Second Response - Remarks

Drawing Objections

Fig. 4

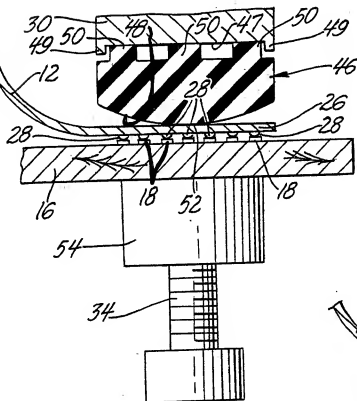
Please substitute the enclosed two new sheets of drawing containing figure 3 and figures 4, 5 and 6, respectively for the corresponding sheets of drawings presently in the case. In figure 3, the section line near the upper right hand corner has been changed to 5-5. In figure 4, the lead line for "48" has been corrected and lead lines for "18" have been added.

The Examiner has objected to the disclosure because "contrary to various statements in the specification (and claims) the arcuate shaped elastomeric pad will not provide a uniform contact pressure. The center of the pad (as viewed in Fig. 4) will provide a greater pressure contact pressure because of the greater amount of resilient material that is compressed between the rigid materials"

Regarding the objection to the disclosure, the Examiner has not specified where the specification states that the elastomeric pad provides a uniform contact pressure. The specification in fact does not state that the elastomeric pad provides a uniform contact pressure. Paragraph 0026 of the specification states "The adjustment is preferably such that the elastomeric pad is resiliently deformed by the clamp housing 30 to provide a *substantially* uniform contact pressure to the elongate array of electrical contacts 28 of the lower contact portion 26 that engages the matching array of electrical contact pads 18 carried by the lower printed circuit board 16." Claims 5, 8 and the Abstract of the Disclosure also refer to "a substantially uniform contact pressure".

The statement of Raymond Jose Norland is enclosed. This statement removes any possible objection to the disclosure and claims.
